AUBURN HILLS 2ND ADDITION

Re: S/D 96-37 - One Step Preliminary-Final Plat of the AUBURN HILLS 2nd ADDITION

At the regular meeting of the Subdivision Committee of the Metropolitan Area Planning Commission on Thursday, June 20, 1996, the above captioned plat was considered. The action of the Committee was to recommend that this plat be approved subject to:

CASE NUMBER: S/D 96-37 AUBURN HILLS 2ND ADDITION

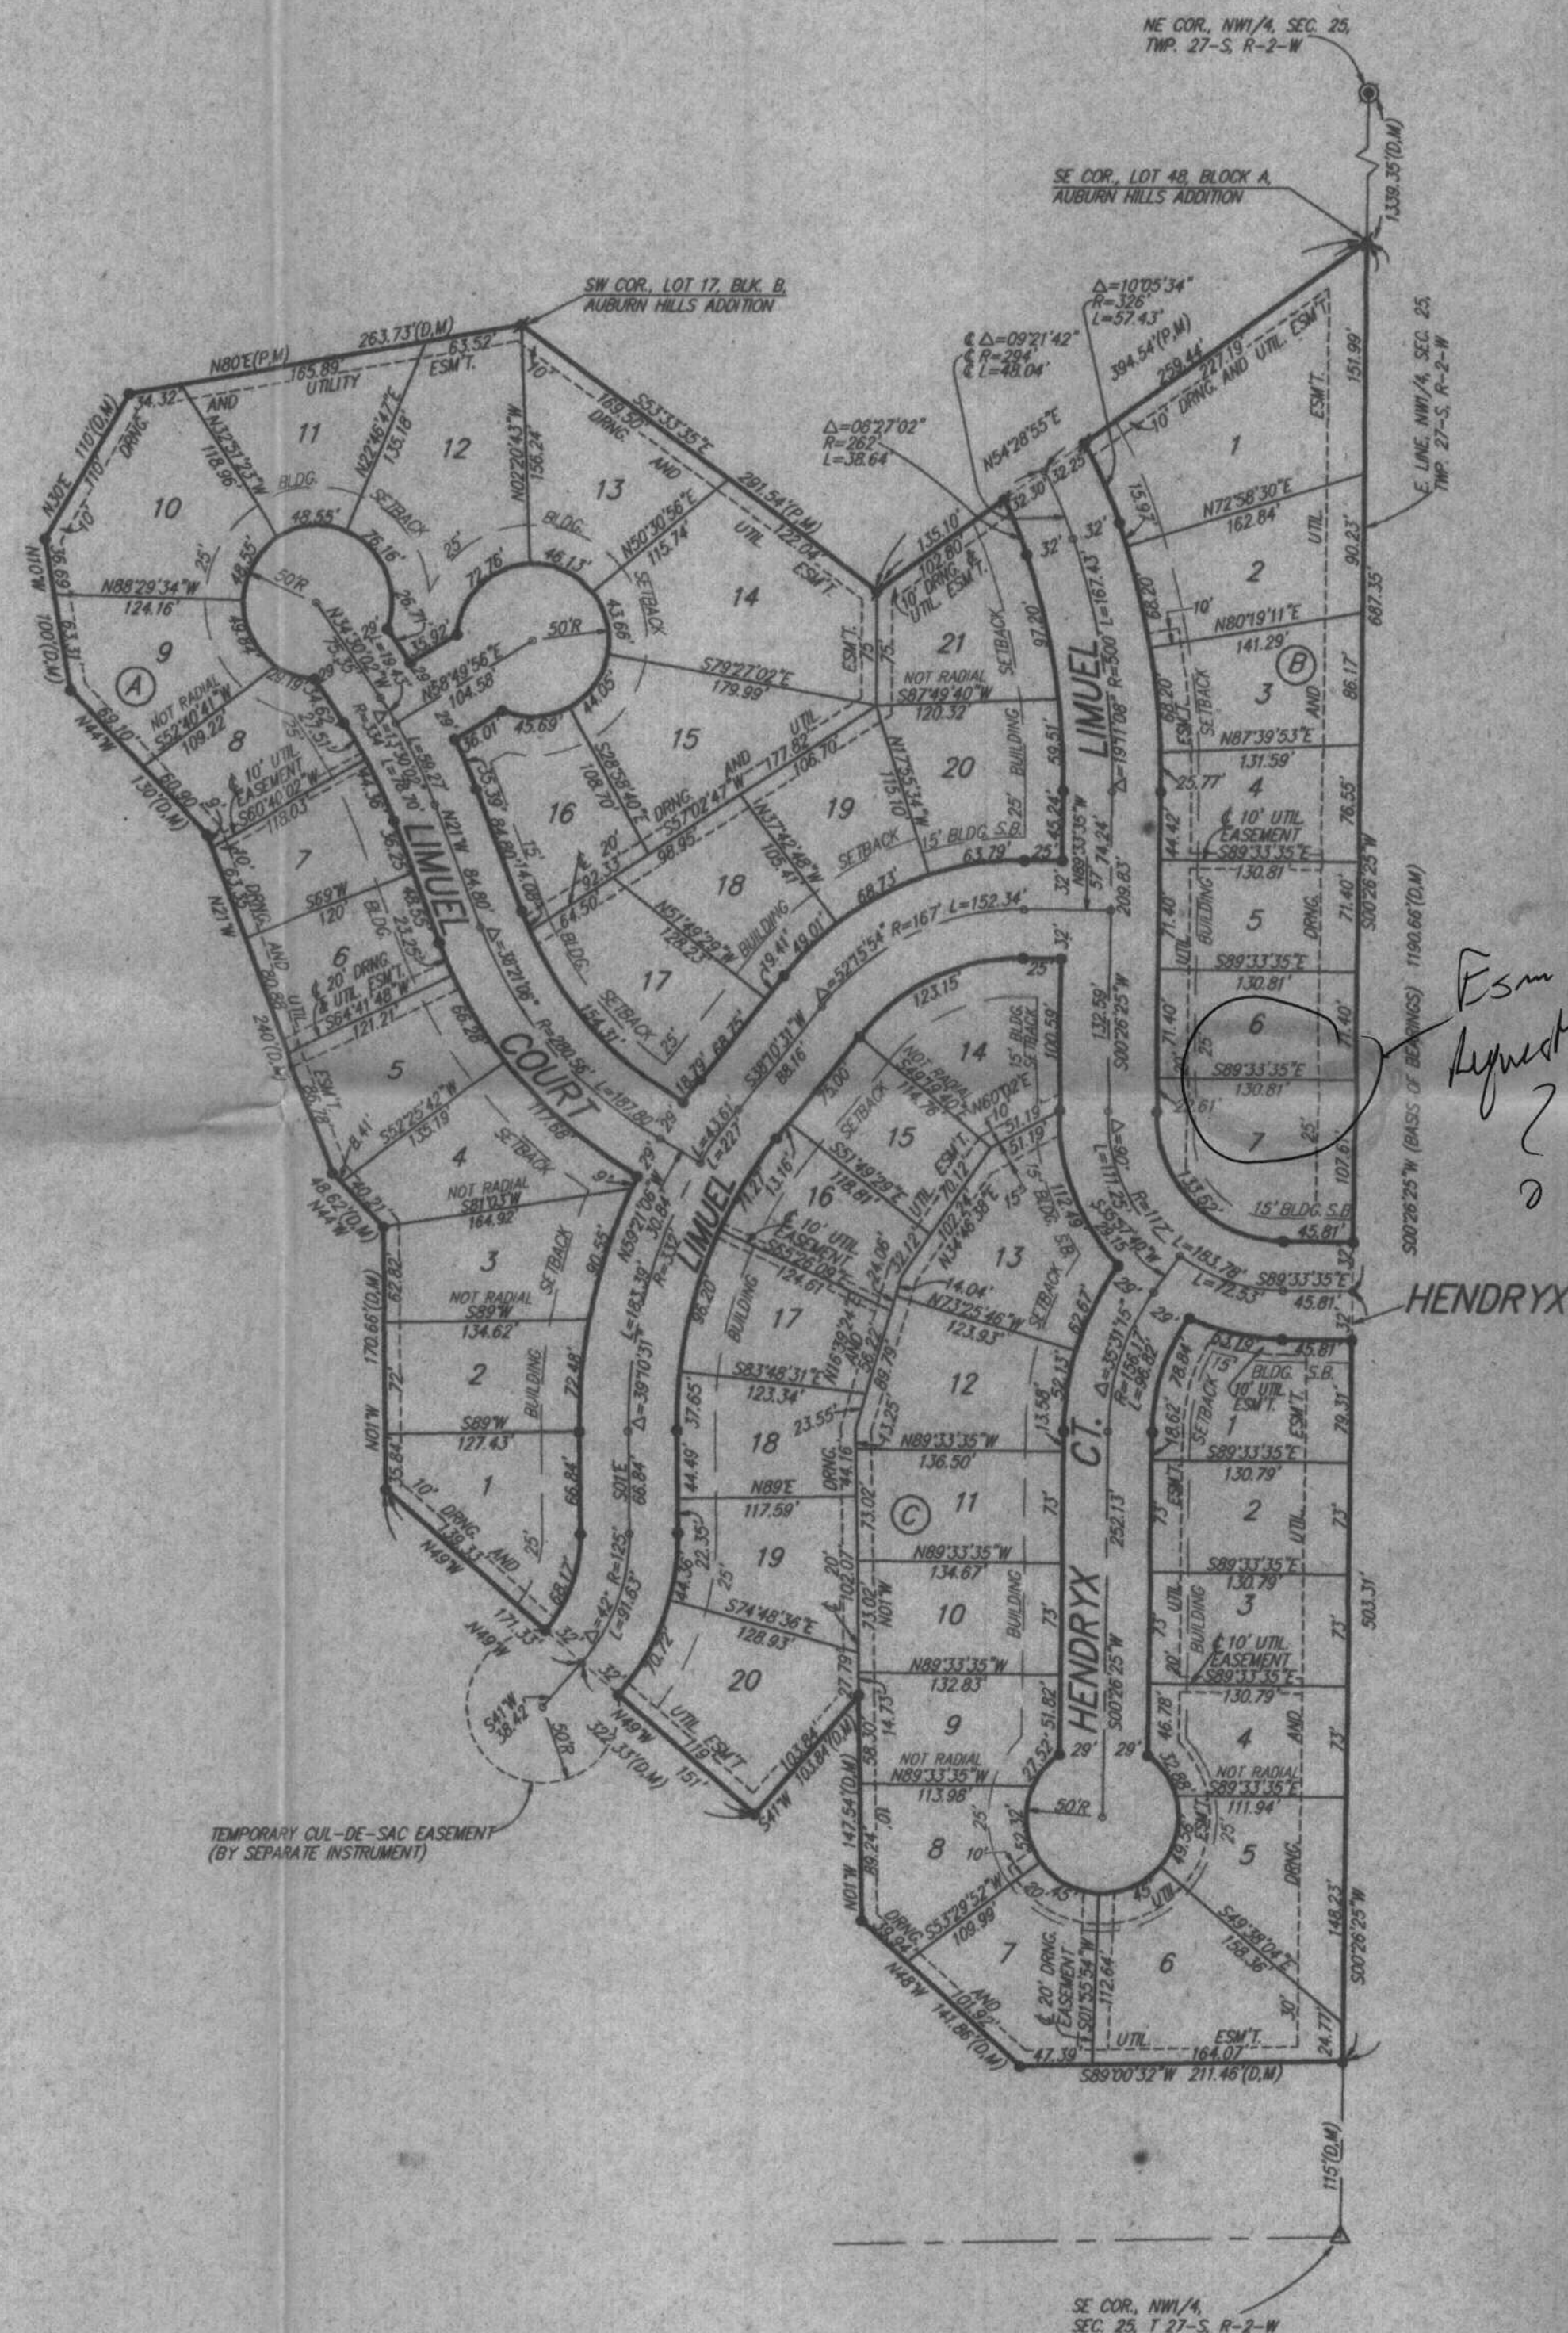
- F. The applicant shall guarantee the paving of the proposed interior streets. This guarantee shall also provide for sidewalks along one side of Limuel and Hendryx (so as to connect to the sidewalk system required in the Maple Valley Addition).

- I. The off-site temporary cul-de-sac needs to be created by separate instrument. Such instrument should be submitted to Planning for processing with the final plat tracing.

- J. The applicant shall submit a covenant which provides for four (4) off-street parking spaces per dwelling unit on each lot which abuts a 58-foot street. The covenant shall inventory the affected lots by lot and block number and shall state that the covenant runs with the land and is binding on future owners and assigns.

- K. On the final plat tracing, the City's signature block shall be amended by deleting "Deputy" from the City Clerk's signature line.
- L. If additional, off-site utility easements are required along the west line of this plat, these easements shall be granted by separate instrument and submitted to Planning for processing with the final plat tracing.

- M. On the final plat tracing, Lot 16, Block A shall be properly depicted. The plat presently shows two (2) Lot 17's at that area of the plat.
- N. The applicant shall install or guarantee the installation of all utilities and facilities which are applicable and described in Article 8 of the MAPC Subdivision Regulations. (Water service and fire hydrants required by Article 8 for fire protection shall be as per the direction and approval of the Chief of the Fire Department.)

- R. Perimeter closure computations shall be submitted with the final plat tracing. Section 5-101(c).
- S. Recording of the plat within 30 days after approval by the City Council.

- T. The final plat shall indicate the utility easements requested by K.G.& E. which are indicated on the enclosed "marked" copy of the plat.

U. The City Fire Department indicated that there are 90° turns on Hendryx and Limuel. The applicant should contact Central Inspection for addressing purposes.
